December 20, 1985

Docket No. 50-245
B11937

Millstone Nuclear Power Station, Unit No. 1
Main Turbine Inspection Program

Figure 1

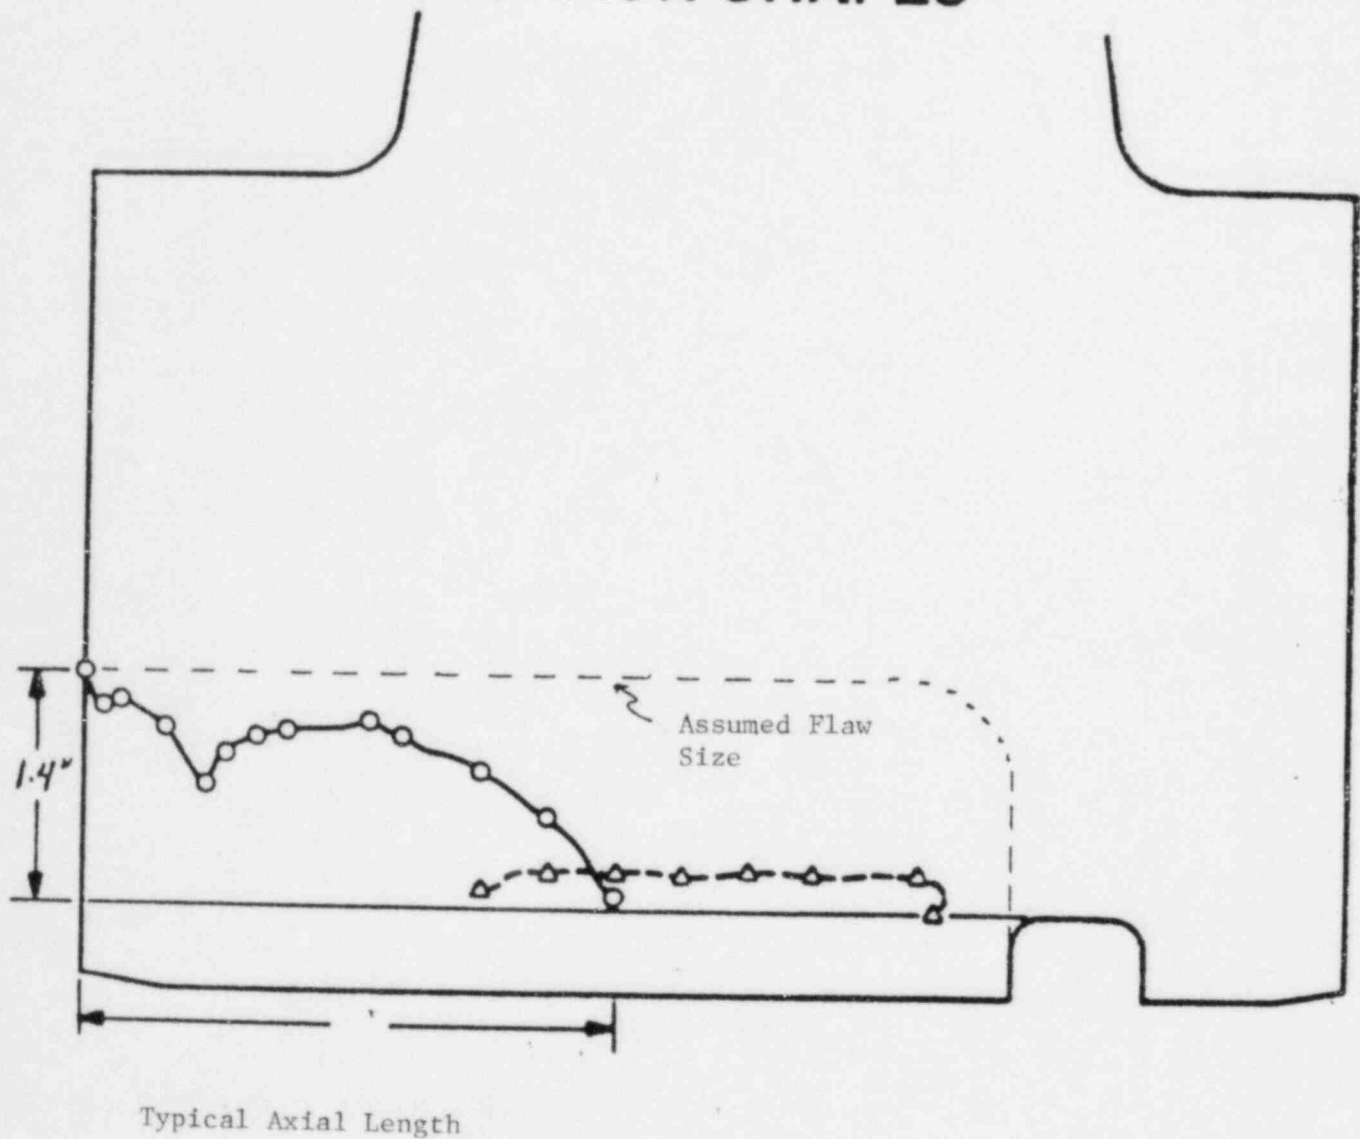
The first question concerned the depth of an indication which was described as "1.4 inches in length". As Figure 1 (attached) shows, the orientation and location of the indication on the wheel relative to the keyway indicates that the reported length of 1.4 inches should be considered as a "radial length". That is, the reported length of the indication could be considered to be the depth of the indication.
